This memorandum presents a summary of the key issues pertaining to the proposed remedial action at the 881 Hillside, the recommendations for resolution of the issues, and the implications for submittal of the final RI/FS reports. The contents of this memorandum were discussed in our meeting with DOE on November 16, 1988. In attendance were Kari Schneider and Greg Underberg representing DOE; Rebecca Weed, Suzanne Paschke, and Mike Anderson representing Weston; Bob James and Tom Greengard representing Rockwell; and Ben Doty.

Figure 1.
BORING & WELL LOCATIONS
FRENCH DRAIN ALIGNMENT

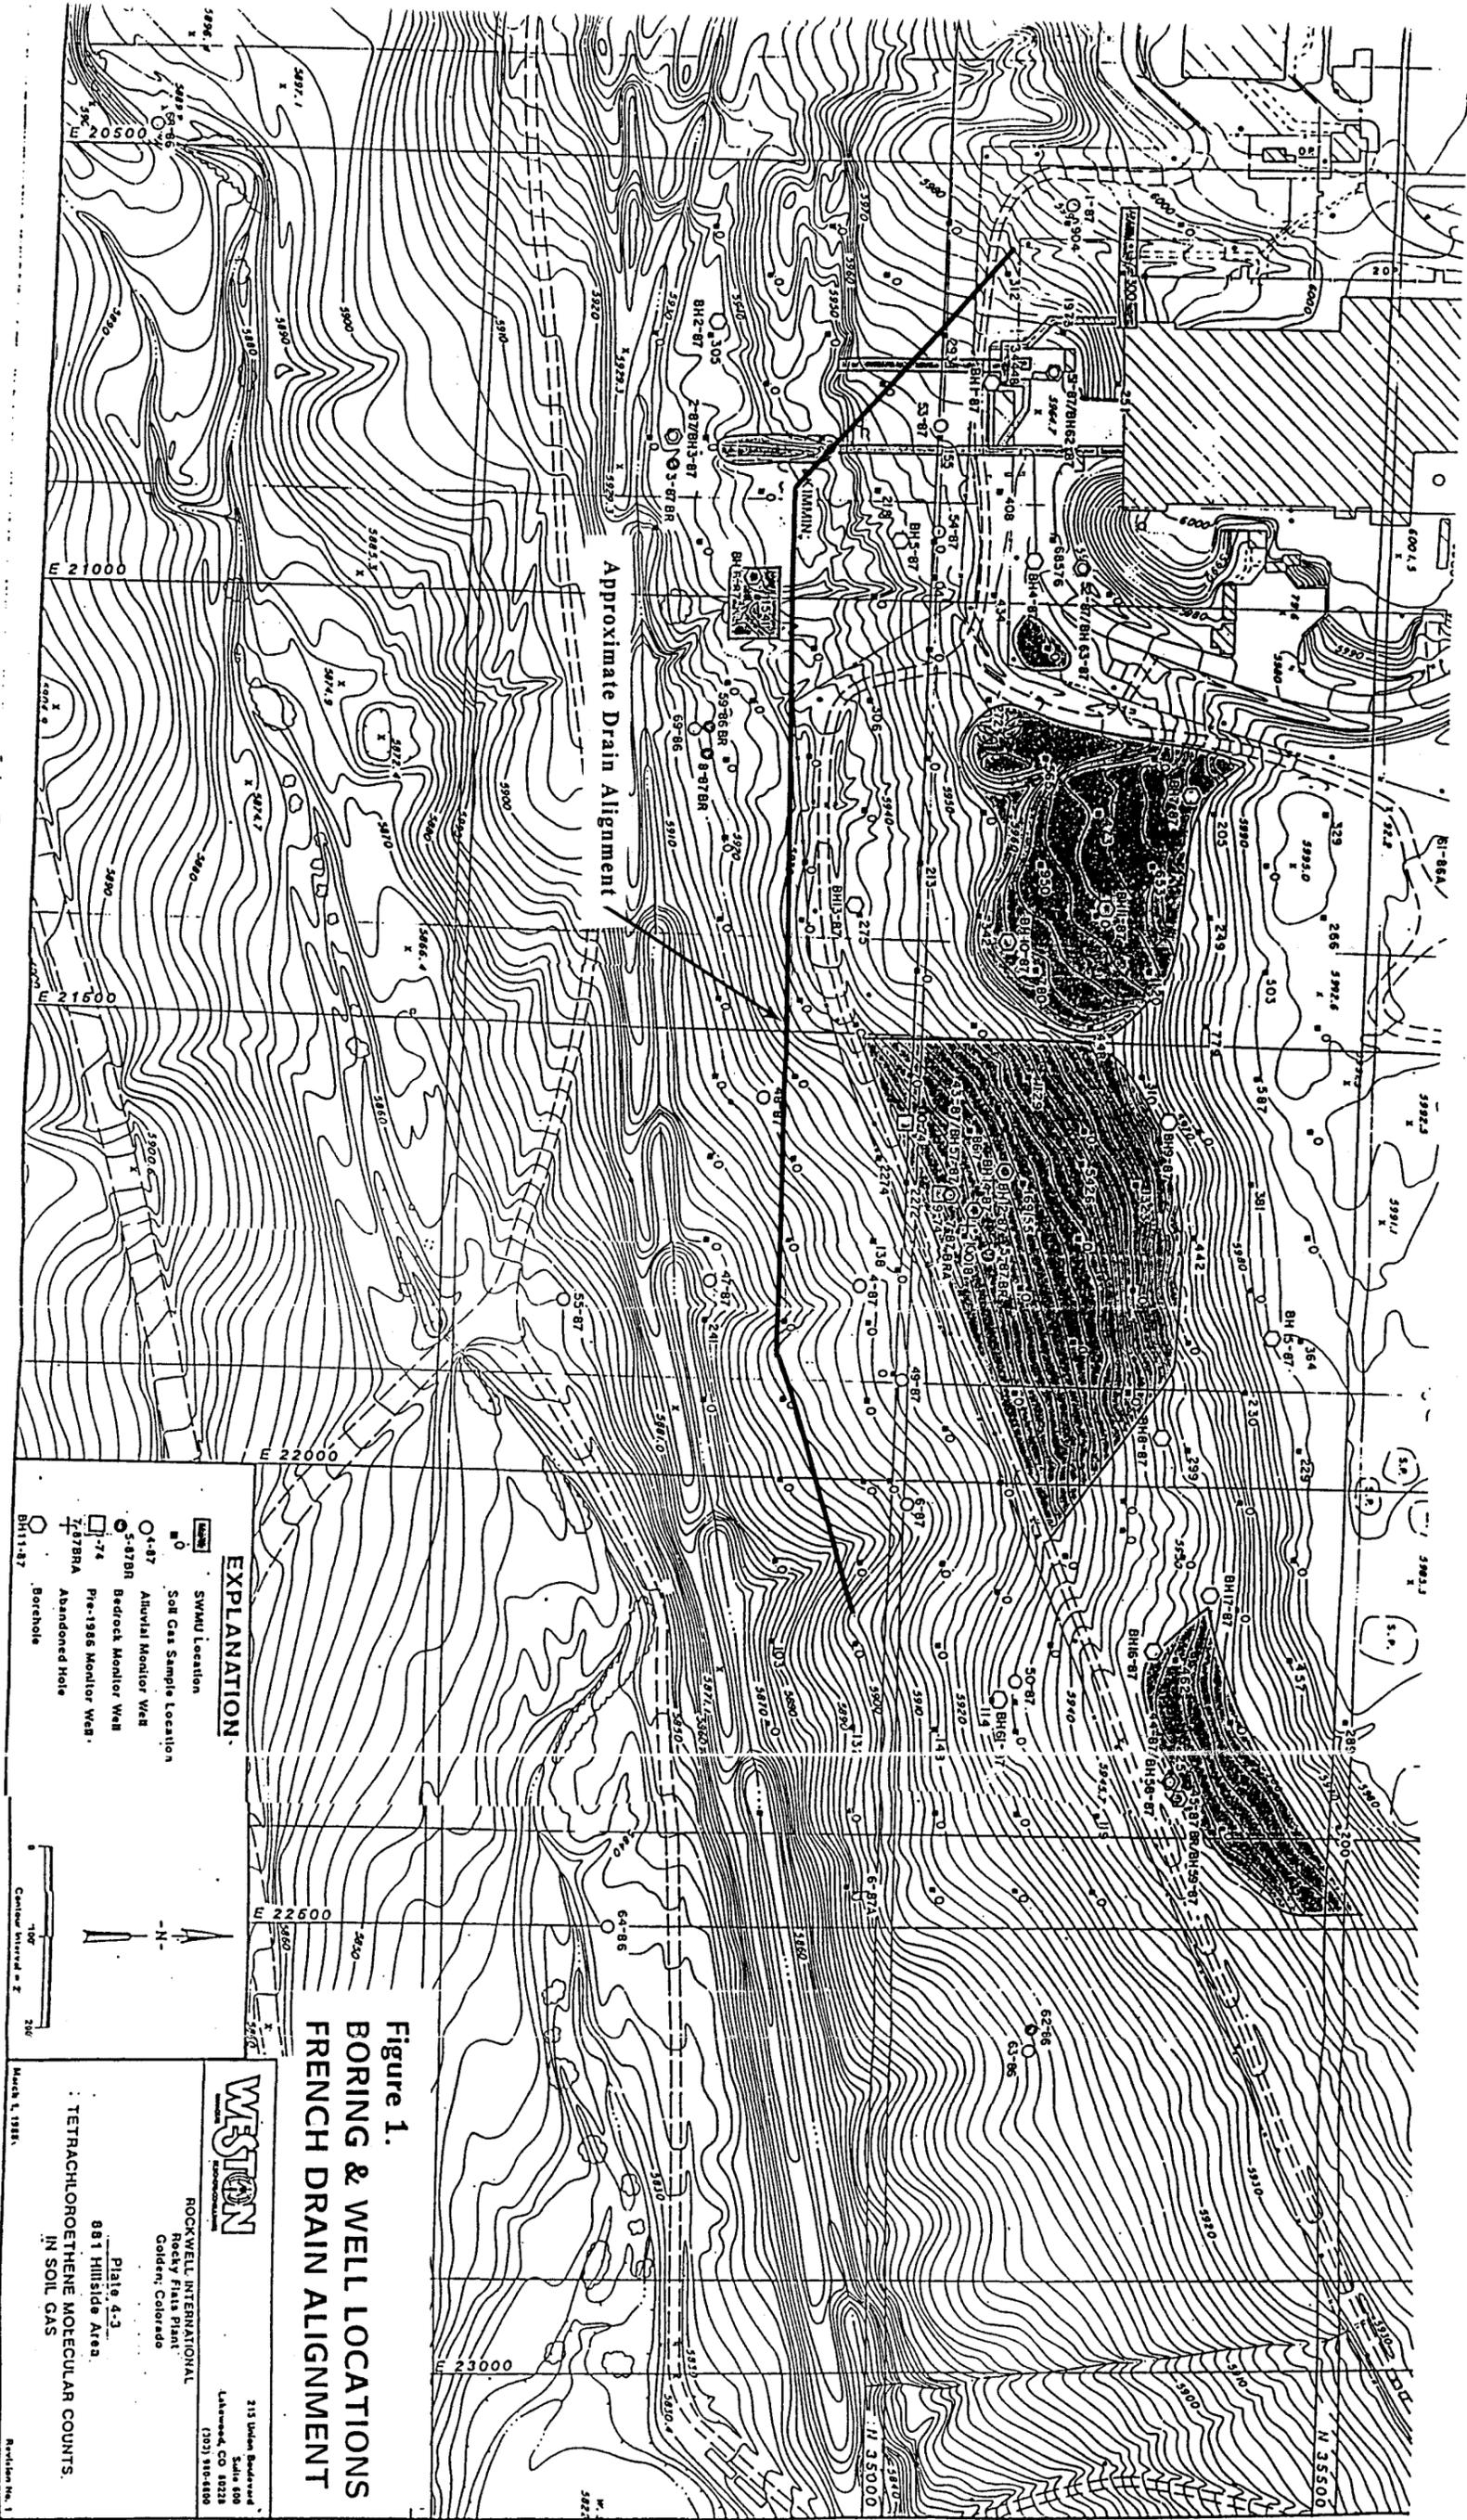
The central issue regarding compliance with ARARs is that until background chemistry is characterized, it is not possible to determine if a variance from meeting these ARARs can be justified, i.e., that background chemical conditions do not meet chemical specific ARARs. Until background has been adequately characterized, the implications of proceeding with the FS preferred remedial action are: 1) discharge to the valley fill alluvium of effluent treated only for organics may be unacceptable to the agencies; 2) the proposed remedial action does not address apparent bedrock ground-water contamination; and 3) the french drain may be improperly located for collection of all "contaminated" alluvial ground water. Table 5 presents the alluvial

wells downgradient of the proposed location of the french drain and the inorganic constituent concentrations above ARAR. The wells are also shown on Figure 1.

The obvious solution to this problem is to collect the necessary background data, determine where variances from ARARs are justified, and then revise the RI/FS so that the preferred remedial action is the cost effective remedy for the 881 Hillside that meets or exceeds ARARs as appropriate. However, the RI/FS reports cannot be finalized for submittal to EPA and CDH until mid 1990 given the time constraints of drilling, sampling, laboratory analysis, data validation, data analysis, and reports preparation and review.
